Jordan School District Riverton Elementary School Remodel

GSBS Project No. 2023.043.00

ADDENDUM NO. 1

February 13, 2024

1/4" = 1'

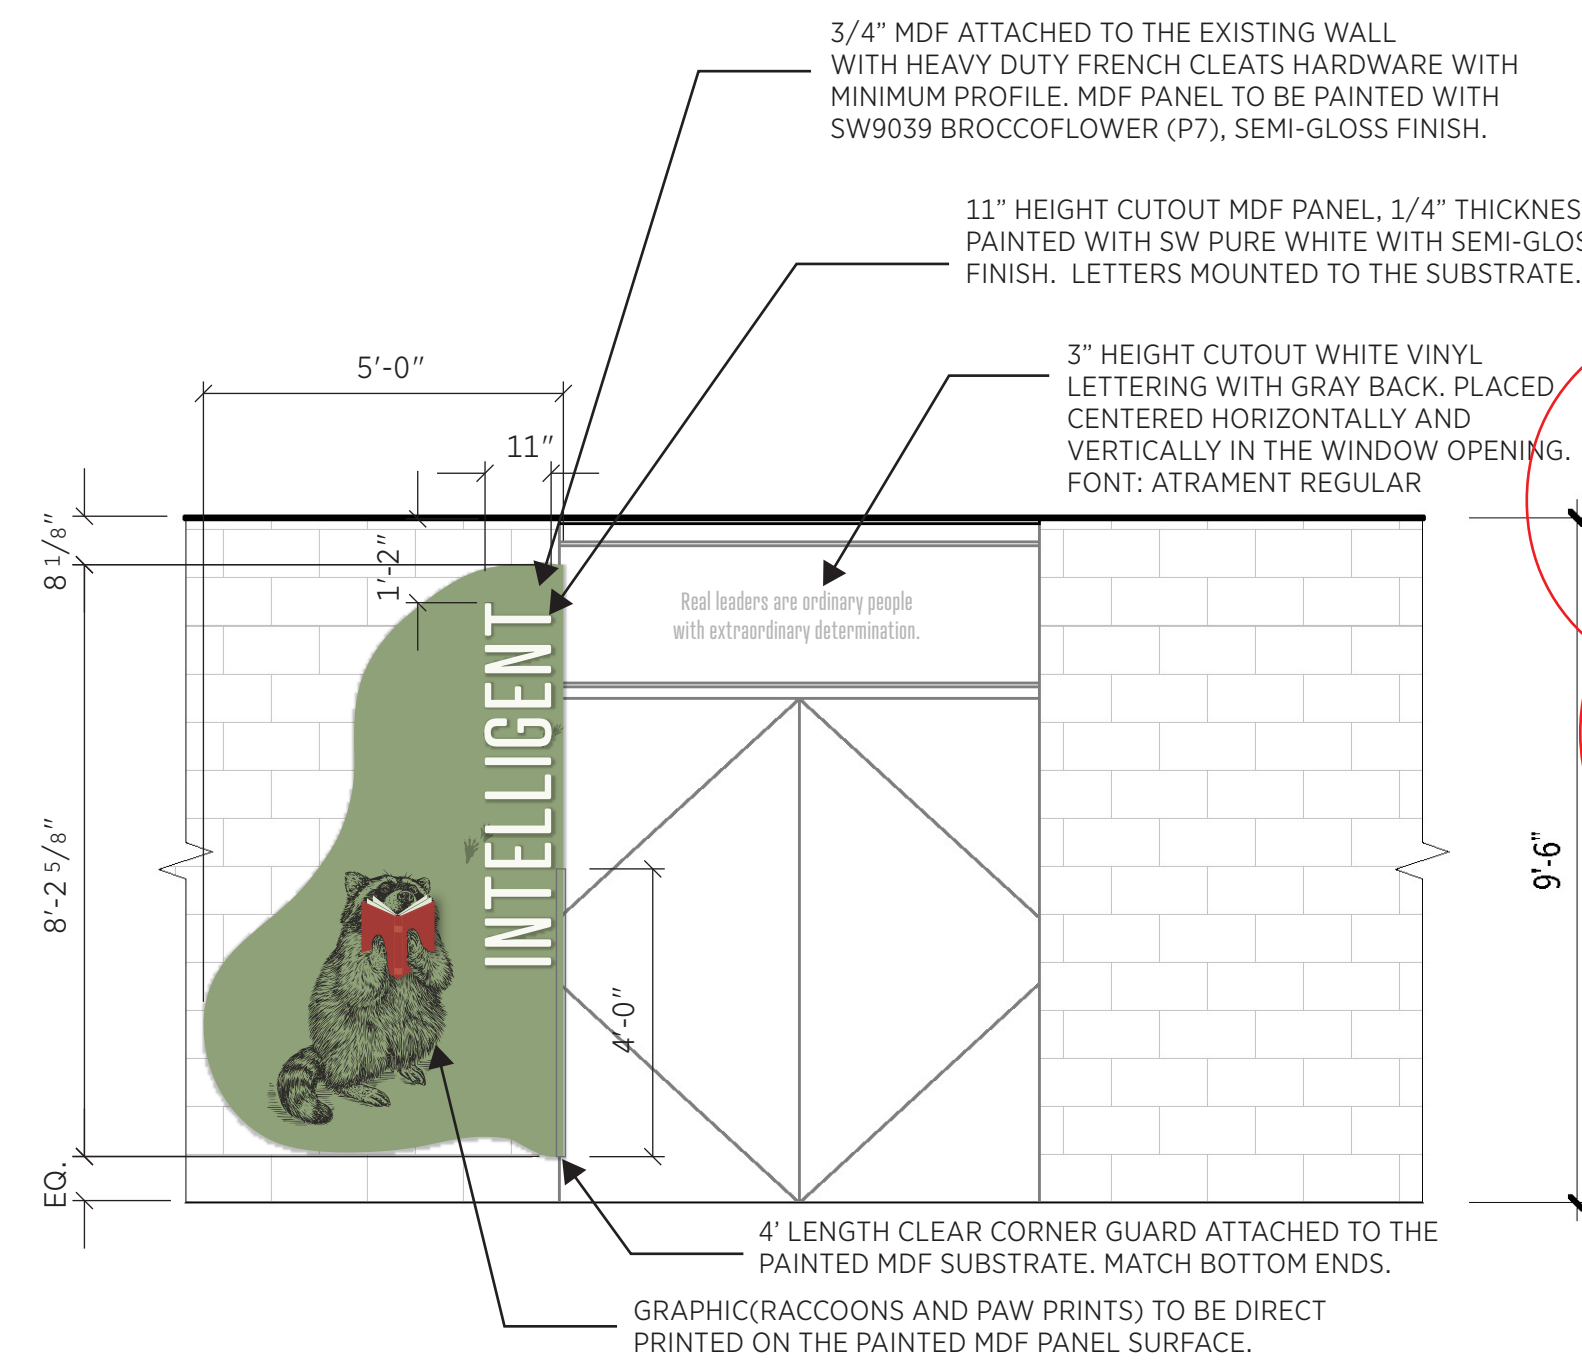
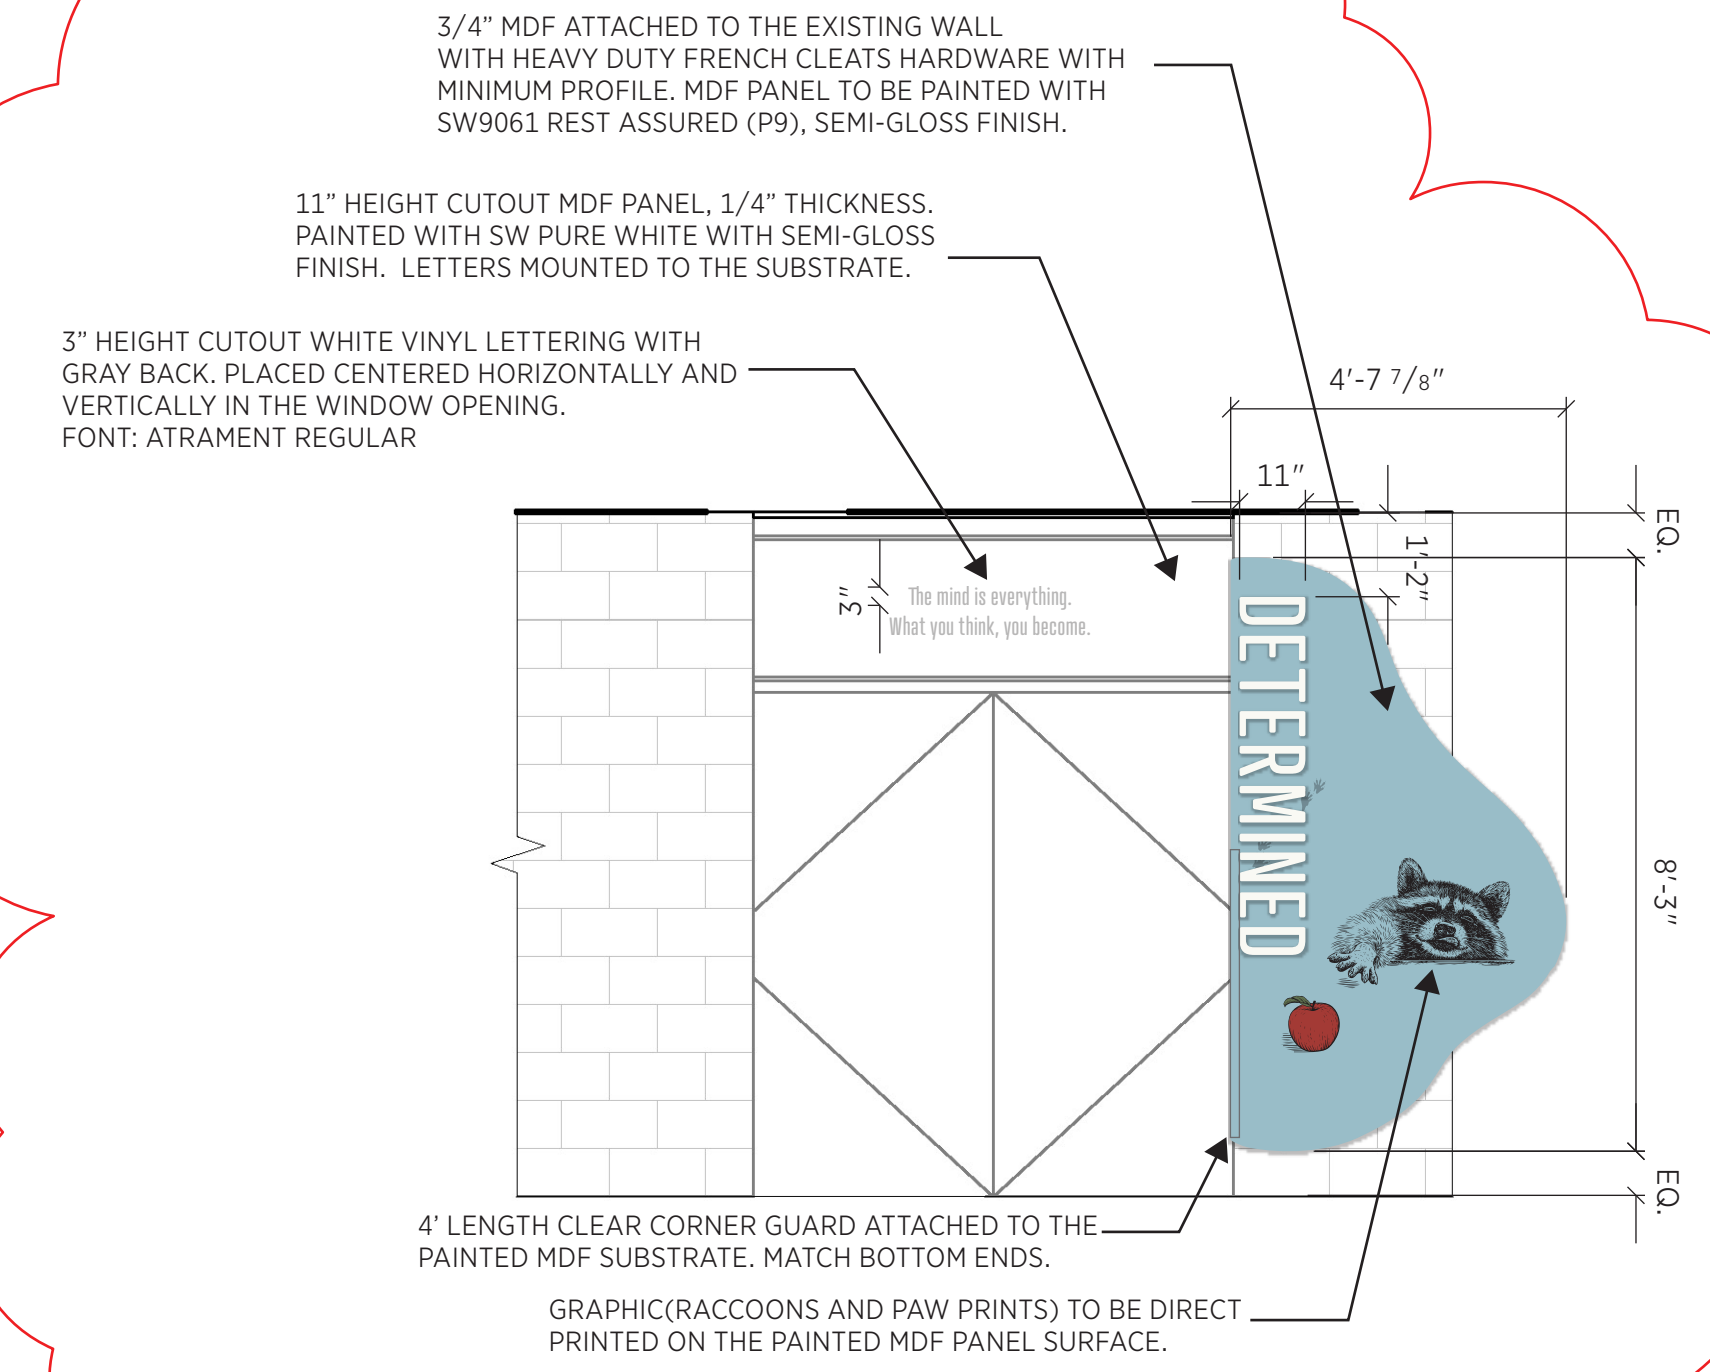
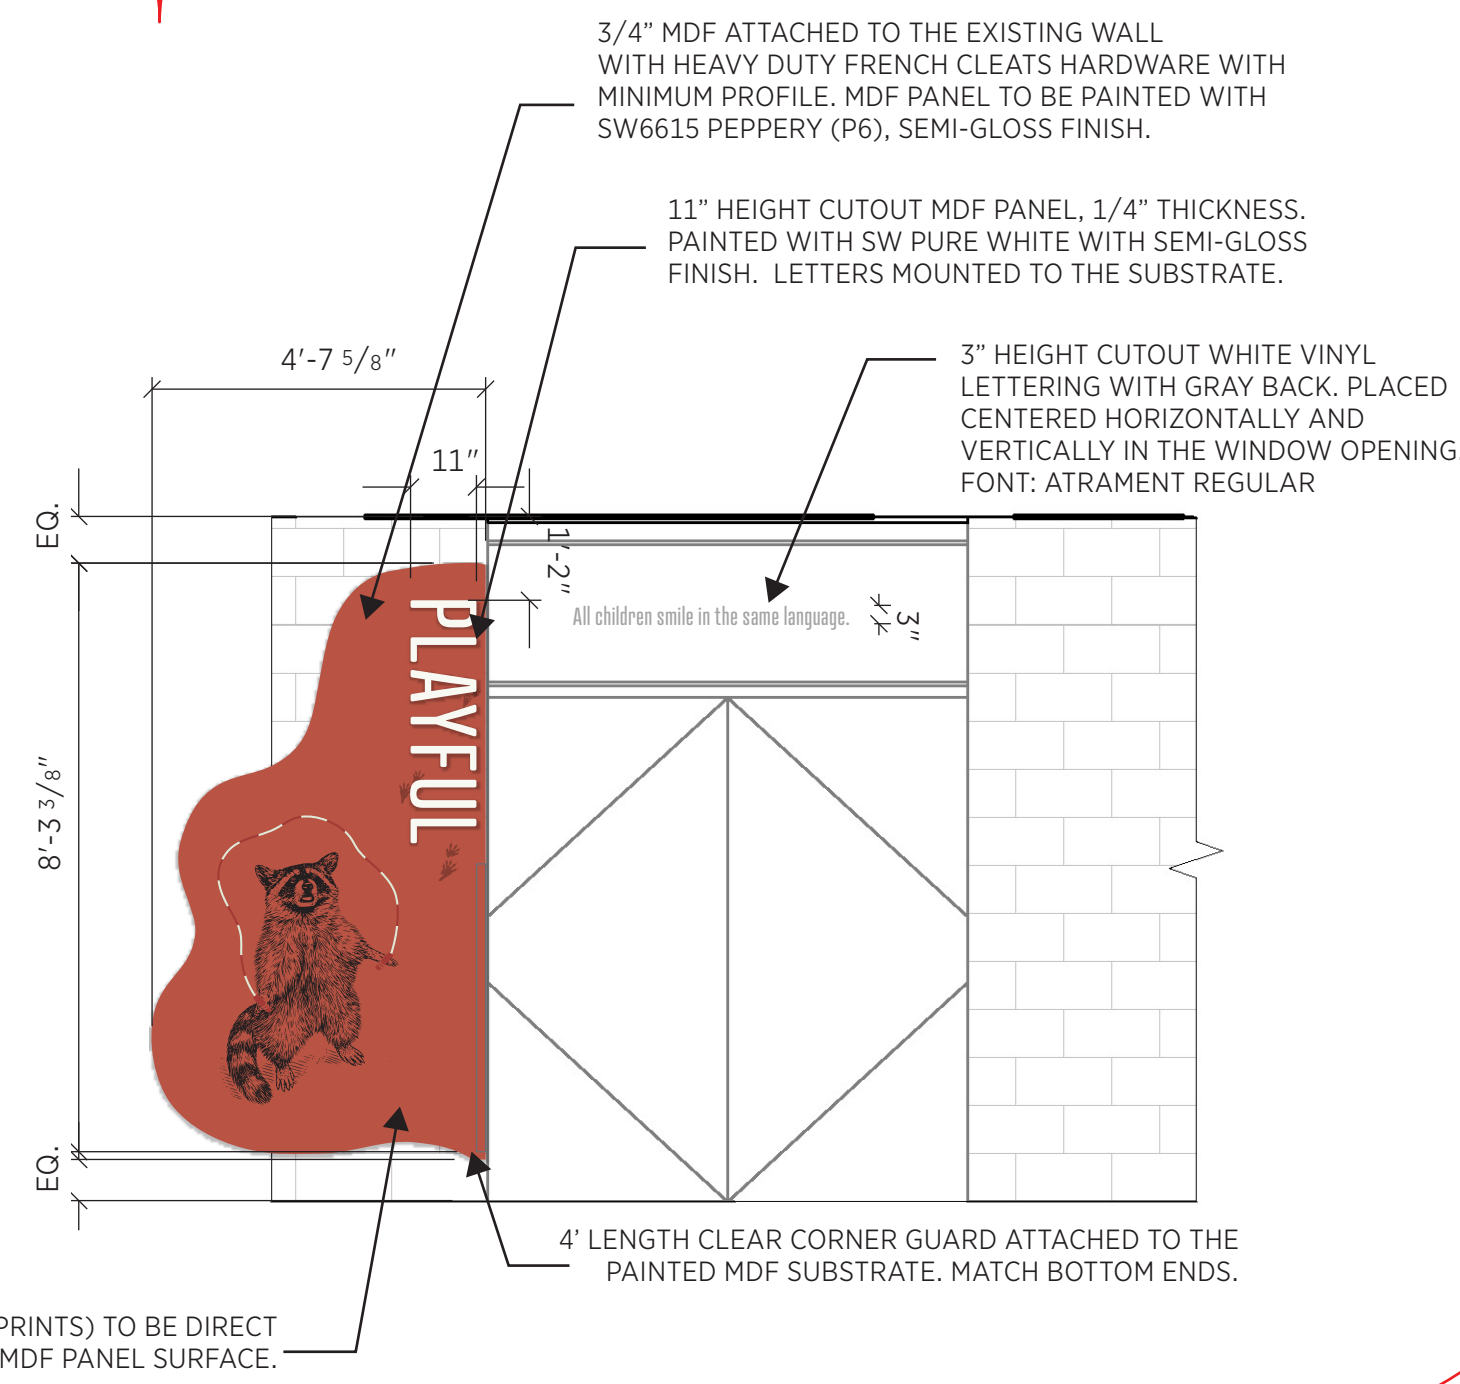
1. Added note to material P4, Comments section.

Article 2.3 - Interior Wayfinding Portal Frames and Jambs for Opaque Finish, add the following: " (Indicated on Drawings as P1, P2, P3, P4, P5)."

LEVEL 1 MECHANICAL PLAN - AREA A

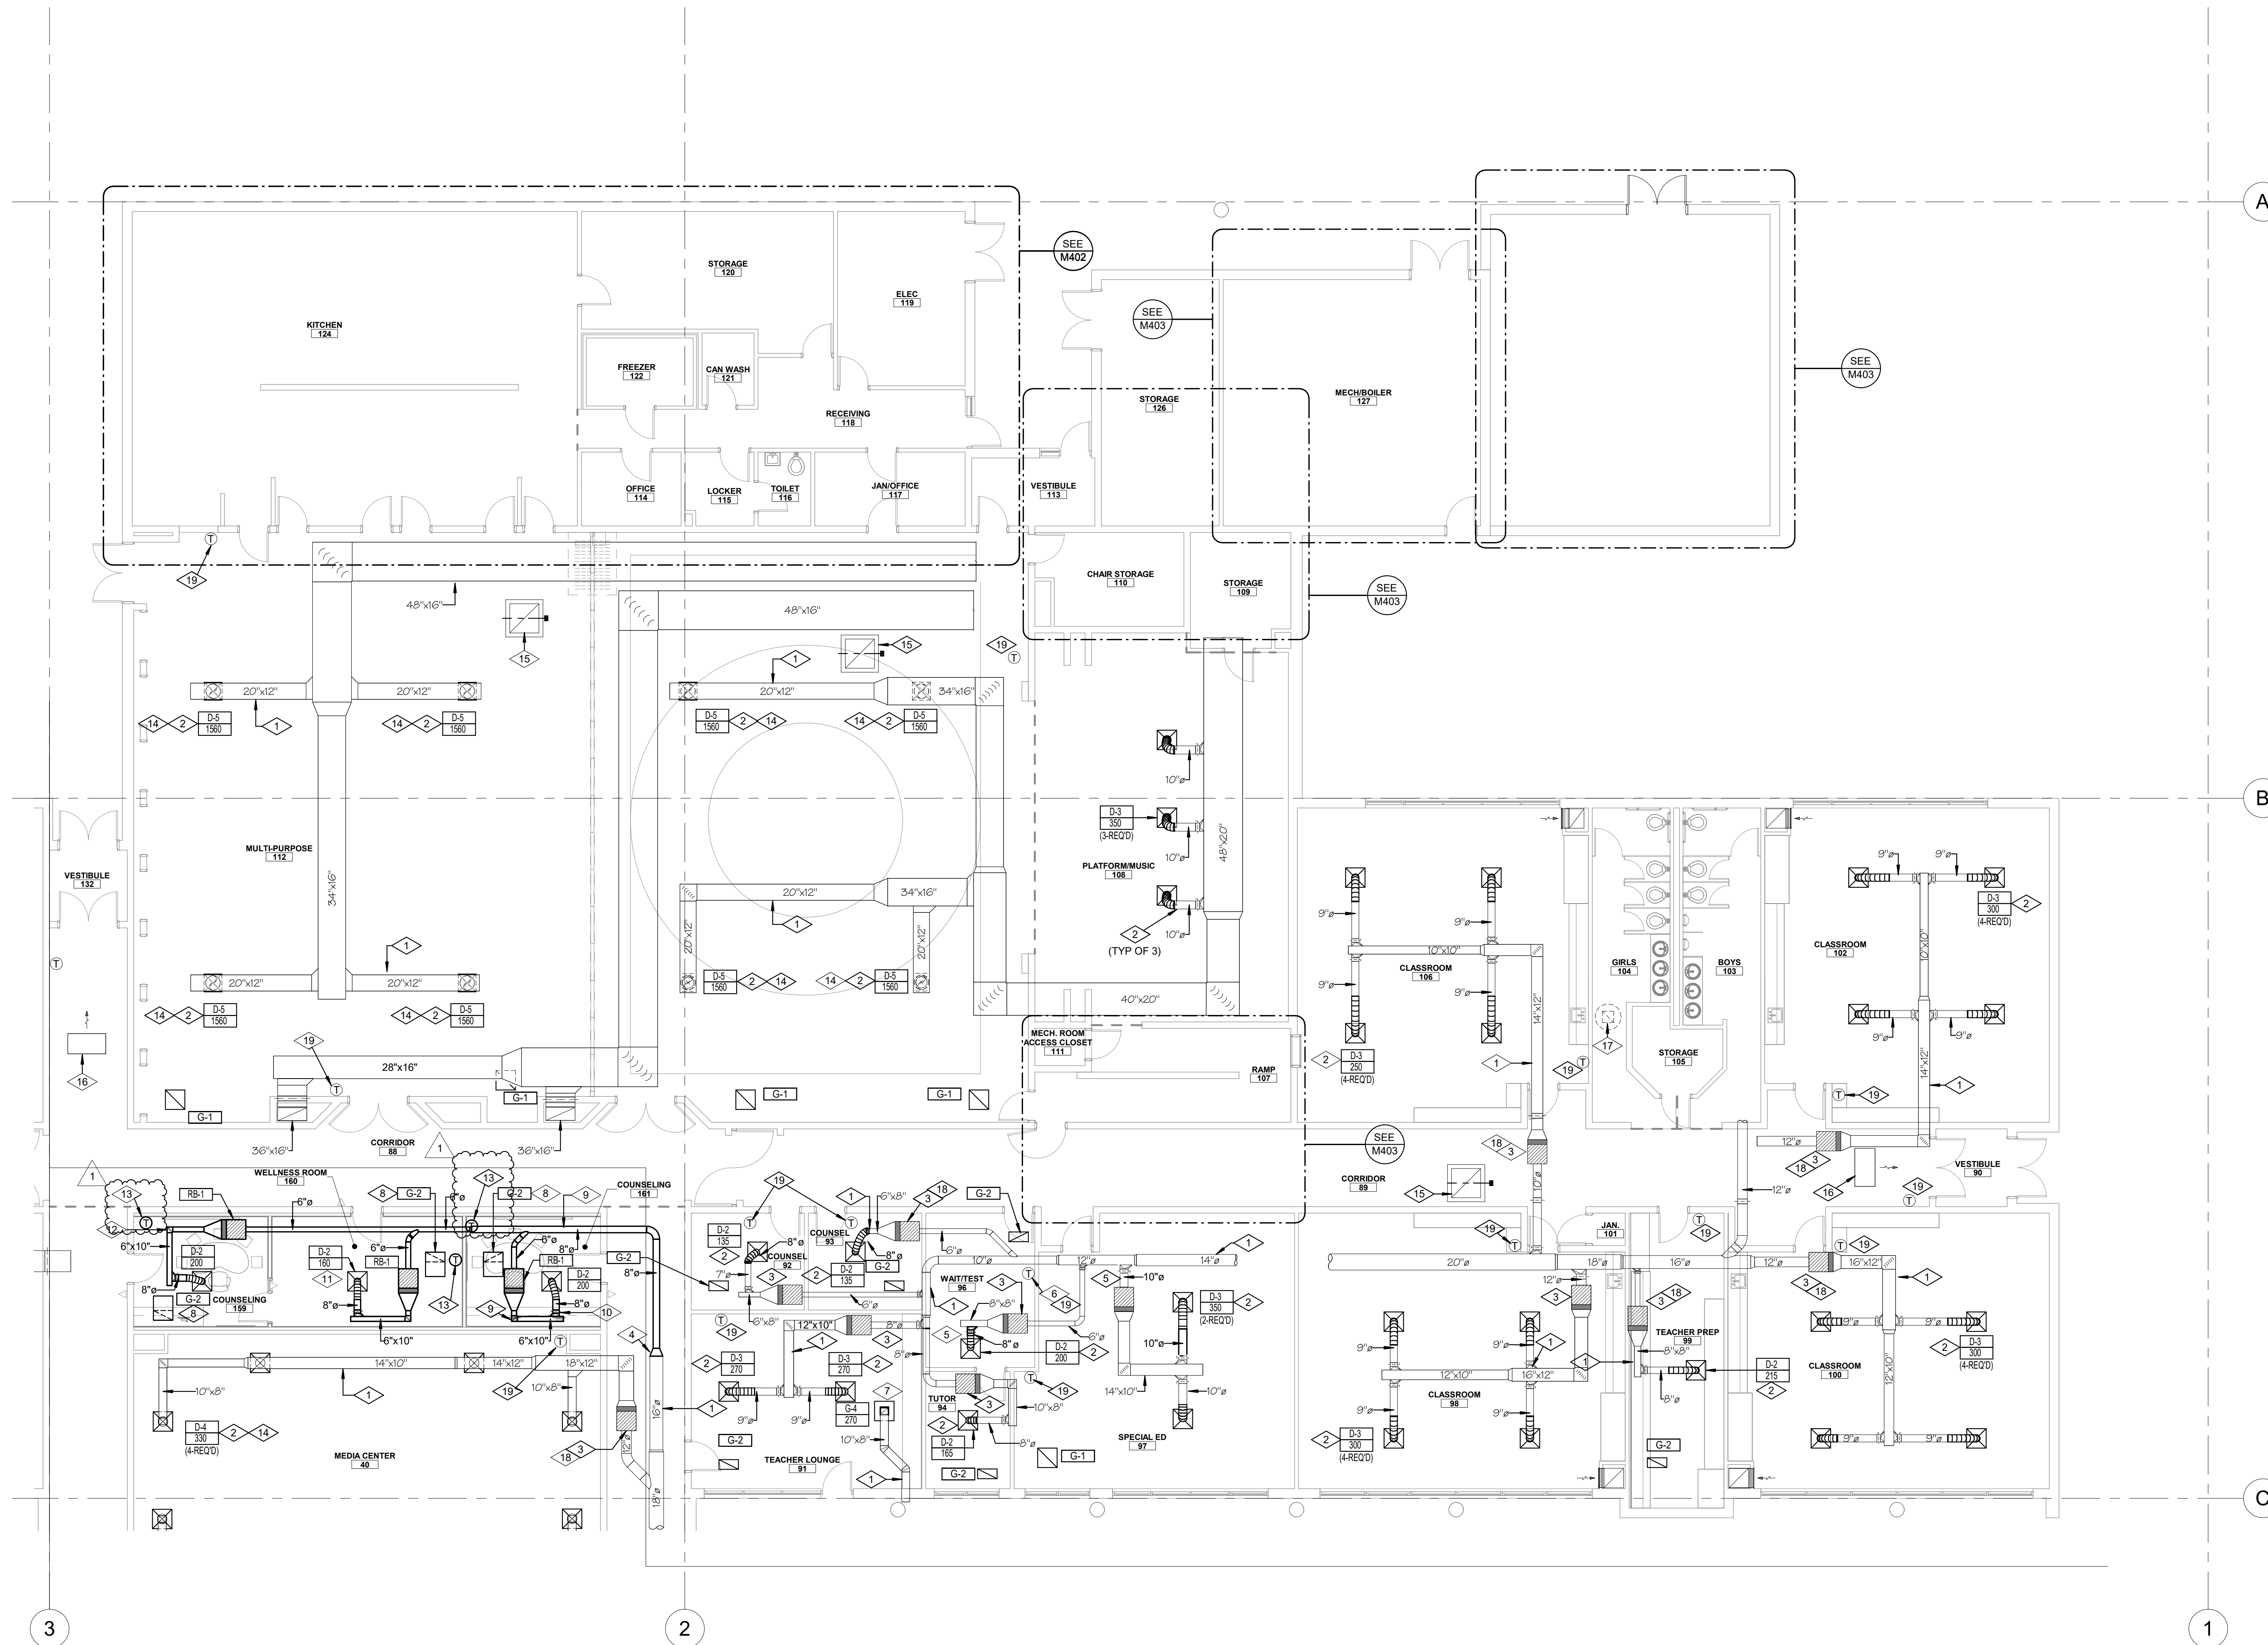
1. Revised thermostat locations.
